Town of Simsbury

Office of Planning & Community Development

SUBJECT: **CC 22-29, 446 Hopmeadow St., Inland Wetlands Application UPDATE**

DRAWING
SL-1
 SHEET NUMBER: 1 OF 2

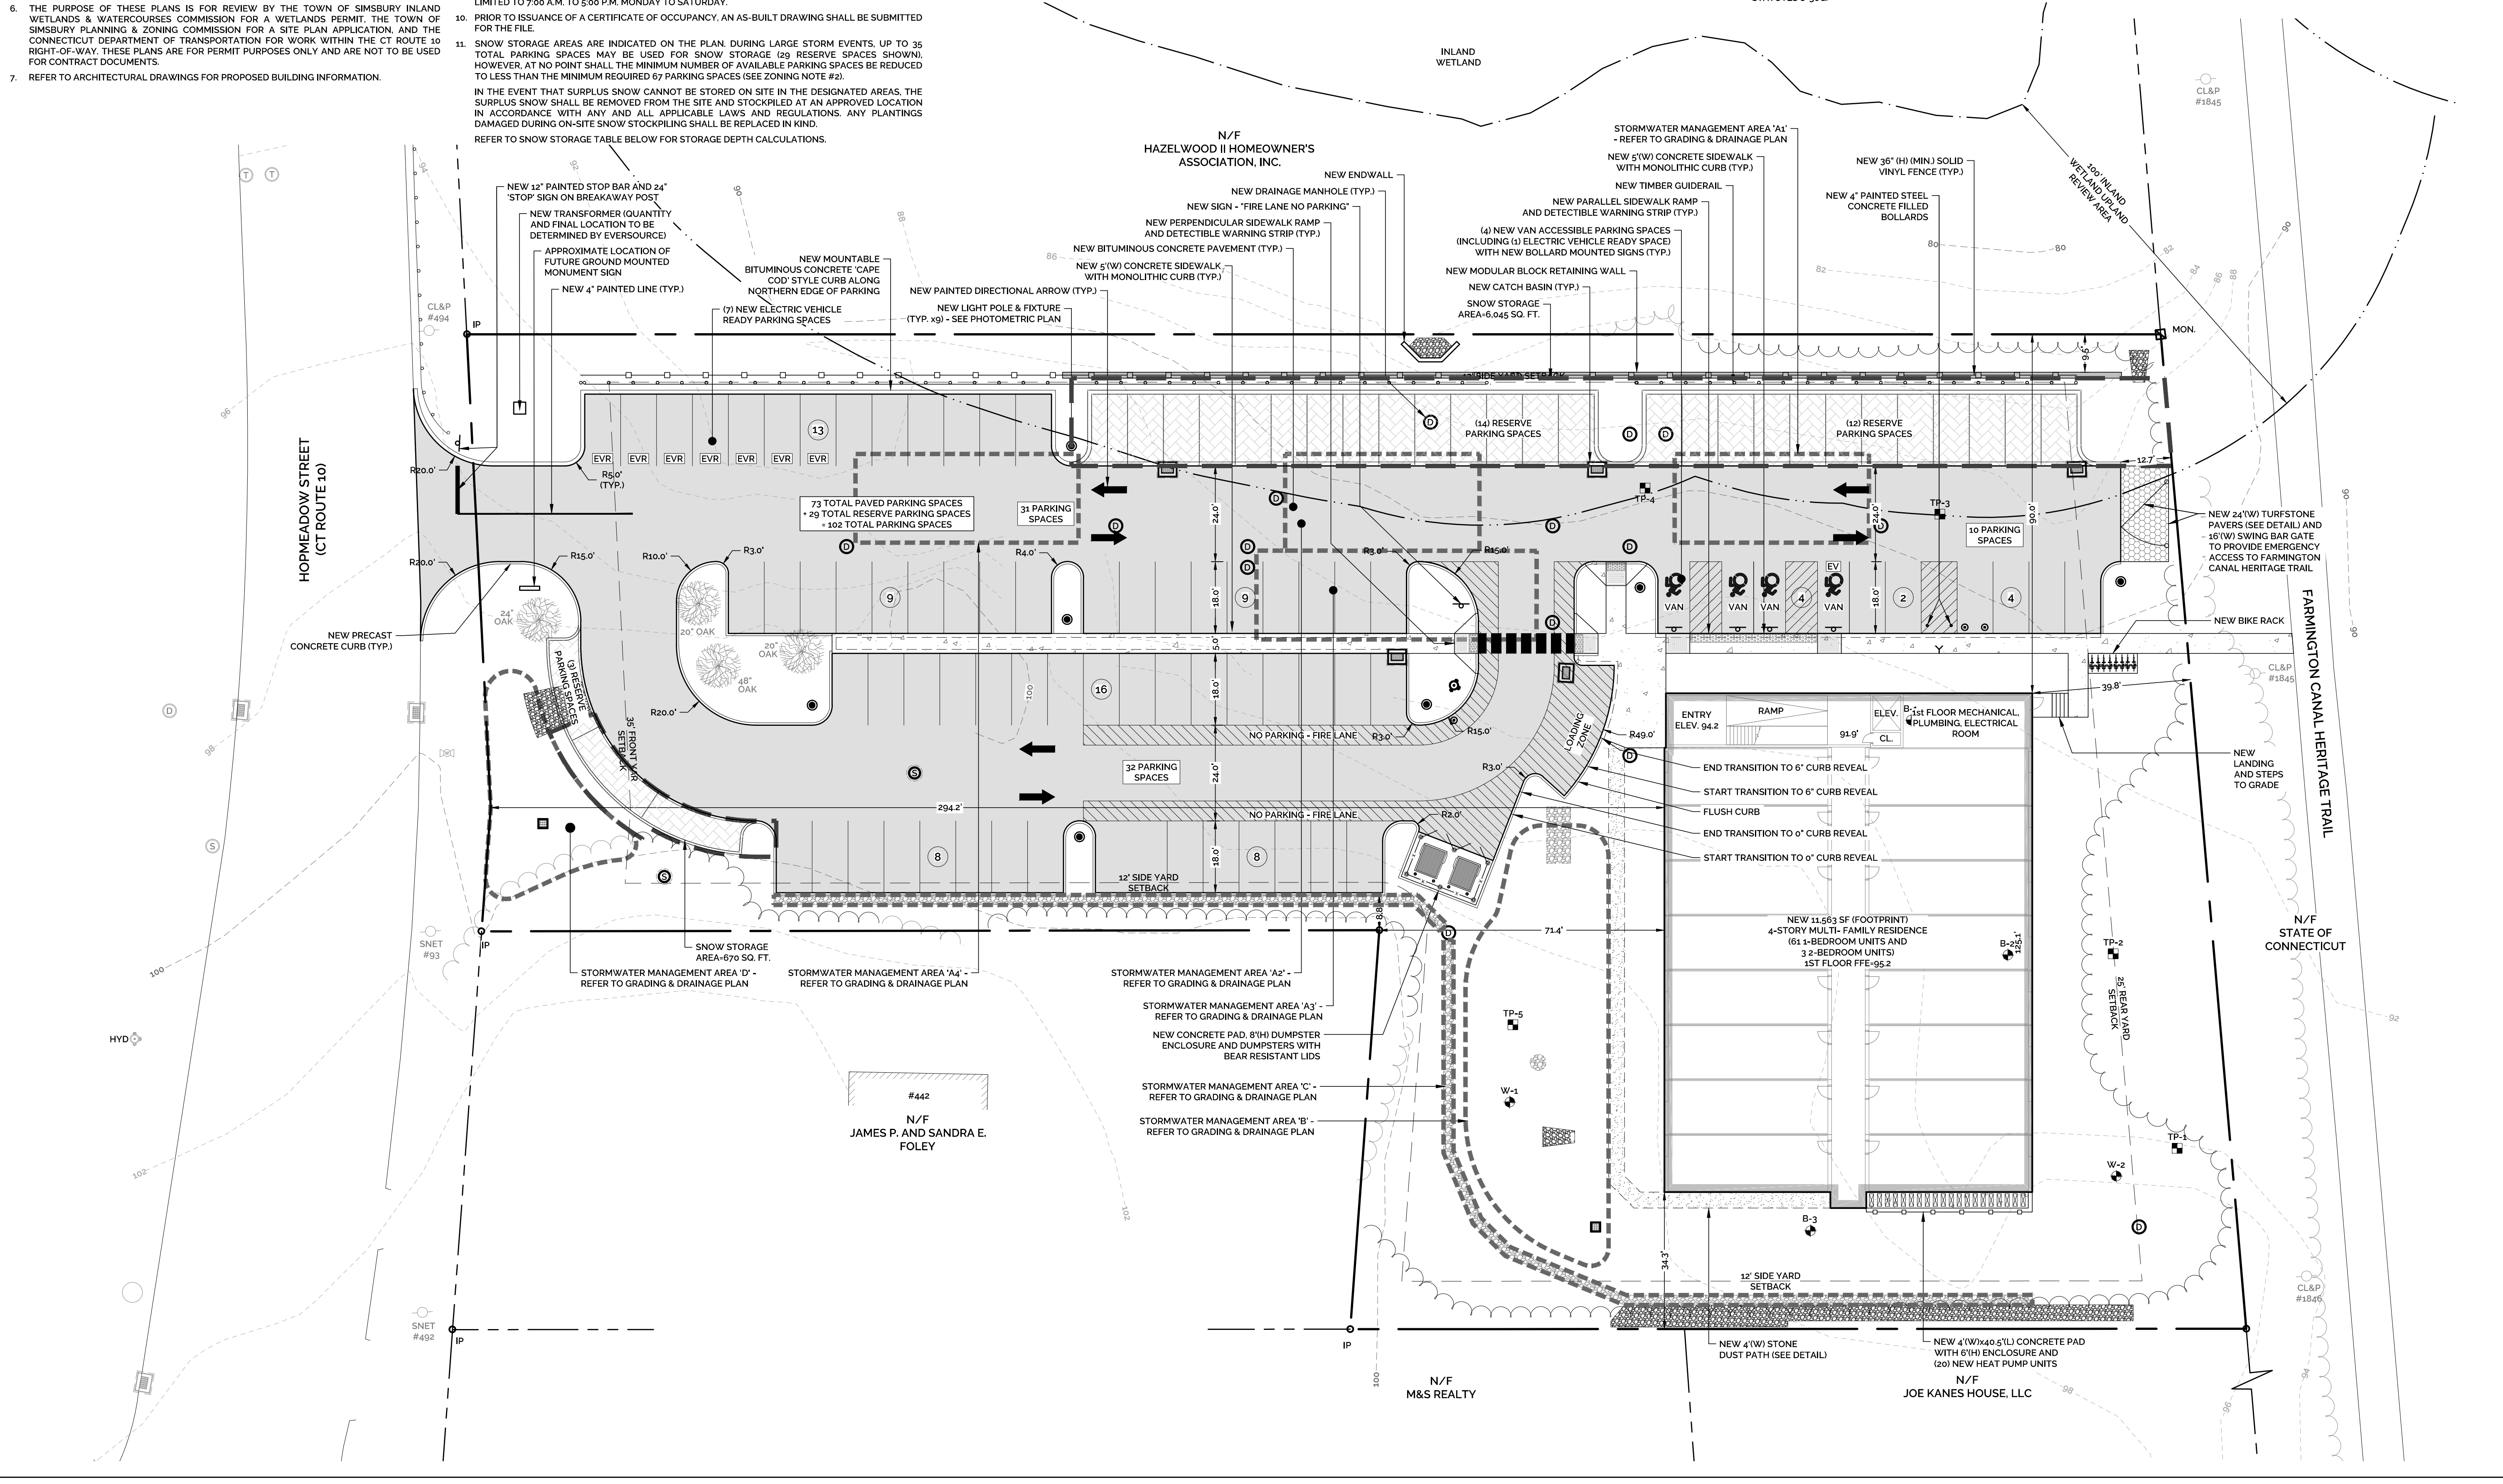
- The revised sheets *reduce* the total number of units from 80 to 64. The building remains at four stories but is reduced in footprint and in square footage from +-56,000 to +-46,000. The setback from the southern property line increases to +-34 feet.
- The revised sheets reserve 29 parking spaces, most on the northern border, within the upland review area. According to the Applicant's testimony, unless a demonstrated need exists, the area would be planted with grass. If they are deemed necessary, those spaces would be constructed using pavers.
- The plan set is attached.
